Title-Sujet:							
Construction of Water Treatment Plant – Norway House							
Solicitation No No. de l'invita	Date						
201900293		June 7 th , 2018					
Client Reference No No. De Référence du Client	Amend No No. du modif.						
201900293							
GETS Reference No No. de Référence de SEAG 201900293							
Solicitation Closes –L'invitatio	n pren	d fin					
at - à 16:00 EDT on - le June 13th, 2018							
F.O.B F.A.B. Destination							
Address Enquiries to: - Adress	er tout	tes questions à:					
jordan.mckenna@rcmp-grc.gc.ca	<u>1</u>						
Telephone No No de telephon	ne	Fax No Nº de FAX:

Part 1 ADDENDUM NO.1

PROJECT NAME: Water Treatment Plant – Norway House

Project: Norway House Water Treatment Plant **Date:** 4 June 2018

Diagram 2

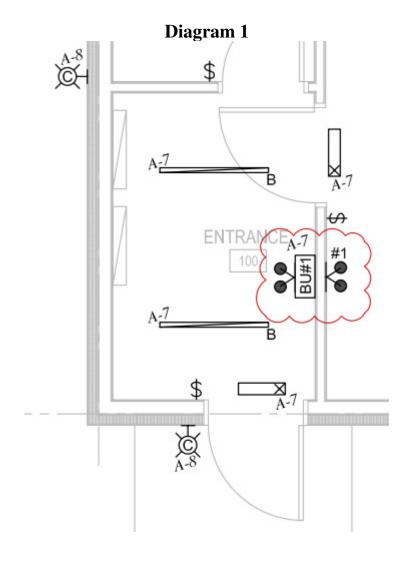
- Refer to Diagram #1. Add a battery unit with double heads and one double remote head in the water treatment plant building. Battery unit is to be Lumacell RG12S-36-2-LD7 or equal. Remote head is to be Lumacell MQM-2-LD7 or equal. Battery unit is to be connected to the lighting circuit in the building.
- 2) Refer to Diagram #2. Add a battery unit with double heads in the pump house building. Battery unit is to be Lumacell RG12S-36-2-LD7 or equal. Battery unit is to be connected to the interior lighting circuit in the building.
